SERVICE BULLETIN

NACELLE - EXHAUST - BRACKET, INBOARD BIFURCATION OVERHEAT DETECTOR -
MODIFICATION OF

V2500-D5

V2500-NAC-26-0012

Inboard Overheat Detector Installation Modification
Figure 1

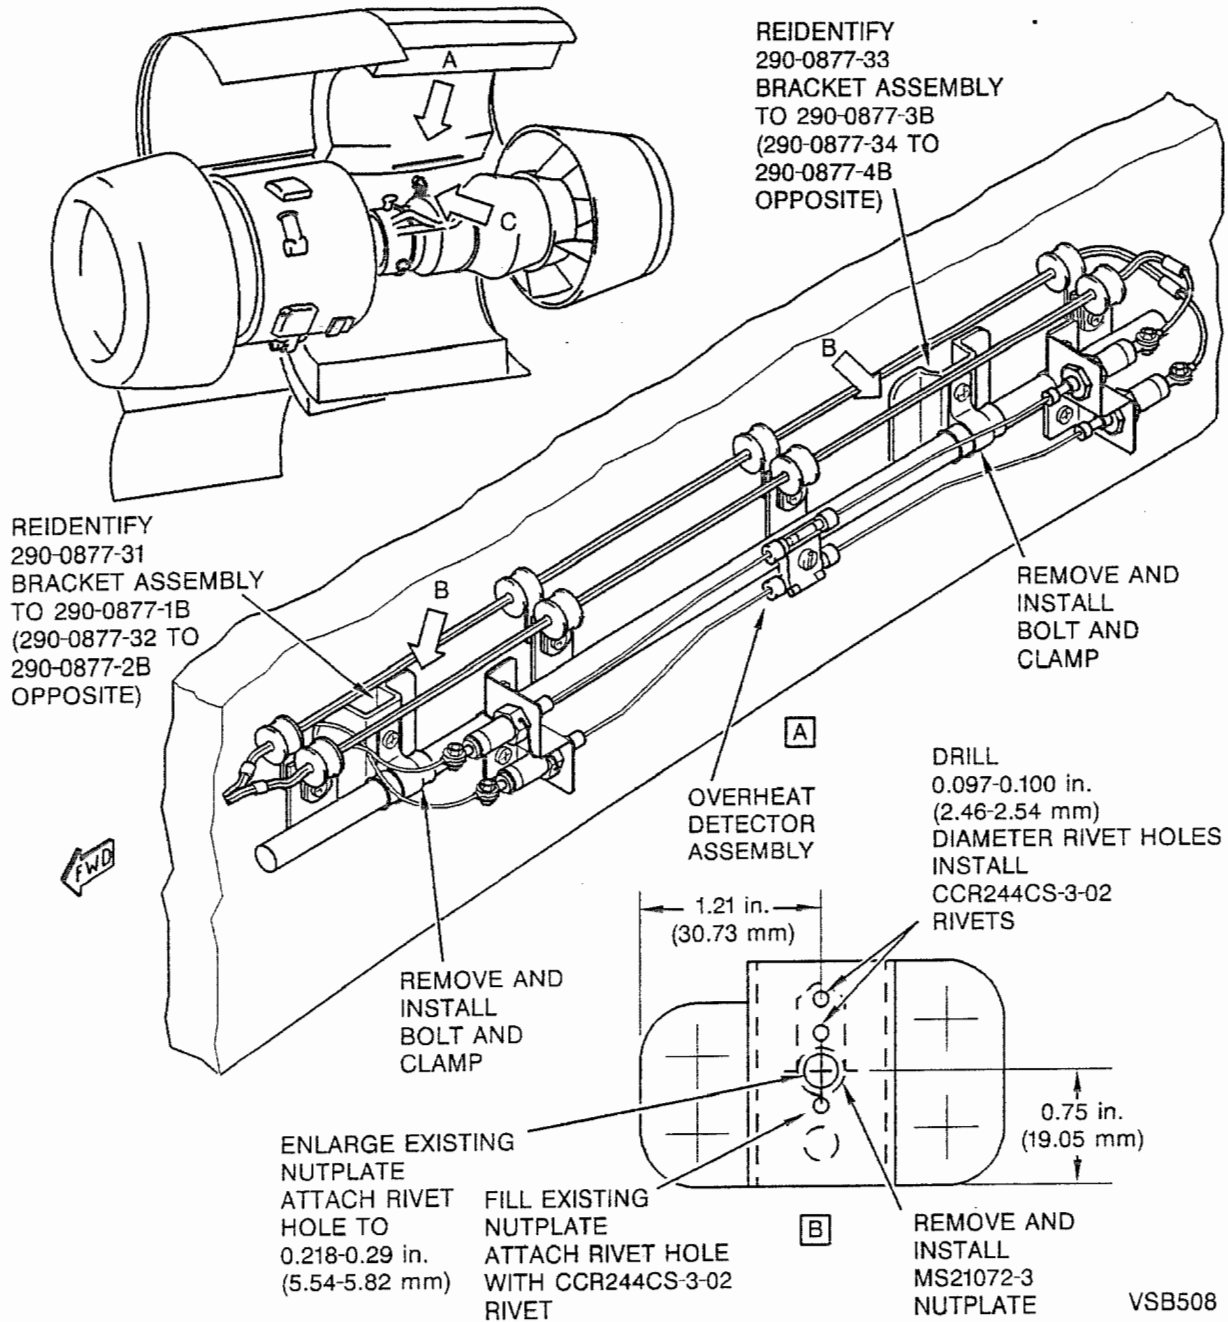
- (1) Remove the inboard bifurcation overheat detector from the 290-0877-31, 290-0877-32, 290-0877-33 and 290-0877-34 brackets on the upper thrust reverser half. Refer to Figure 1.

- (1) Remove the rivets and nutplates from the 290-0877-31, 290-0877-32, 290-0877-33 and 290-0877-34 brackets. Refer to Figure 1.
- (2) Install a CCR244CS-3-02 rivet to fill one of the nutplate attach rivet holes. Refer to Figure 1.
- (3) Enlarge the other existing nutplate attach rivet hole to 0.218-0.229 inch (5.54-5.82 mm). Refer to Figure 1.
- (4) Drill the holes for the new nutplate attach rivets. Refer to Figure 1.
- (5) Install the MS21072-3 nutplates with the CCR244CS-3-02 rivets. Refer to Figure 1.
- (6) Reidentify the brackets as follows:

290-0877-31 as 290-0877-1B
290-0877-32 as 290-0877-2B
290-0877-33 as 290-0877-3B
290-0877-34 as 290-0877-4B

Elbow Duct Assembly
Figure 2

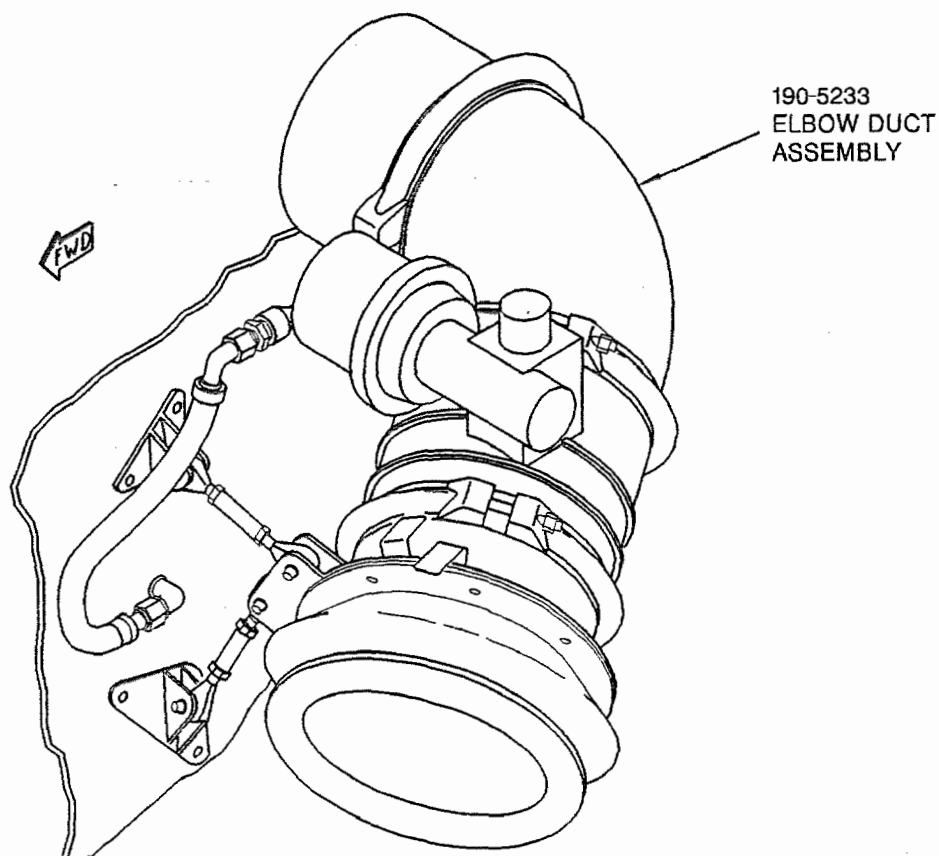
- (1) Examine and repair damage to the 290-5233 fan air elbow duct as follows. Refer to Figure 2:

- 1 0.007 inch (0.18 mm) or less in depth and 1.7 inch (43.2 mm) or less in length -Blend out the damage.
 - 2 Larger than in 1, replace the duct.

- 1 Dent 0.64 inch (16.2 mm) or less in diameter and 0.043 inch (1.09 mm) in depth is acceptable.
 - 2 Larger than in 1, replace the duct.

- 1 Dent 0.50 inch (12.7 mm) or less in diameter and 0.033 inch (0.84 mm) in depth with a nick scratch or gouge as in (a)1. - Blend out the damage.
 - 2 Larger than in 1, replace the duct.

- 1 No cracks allowed.
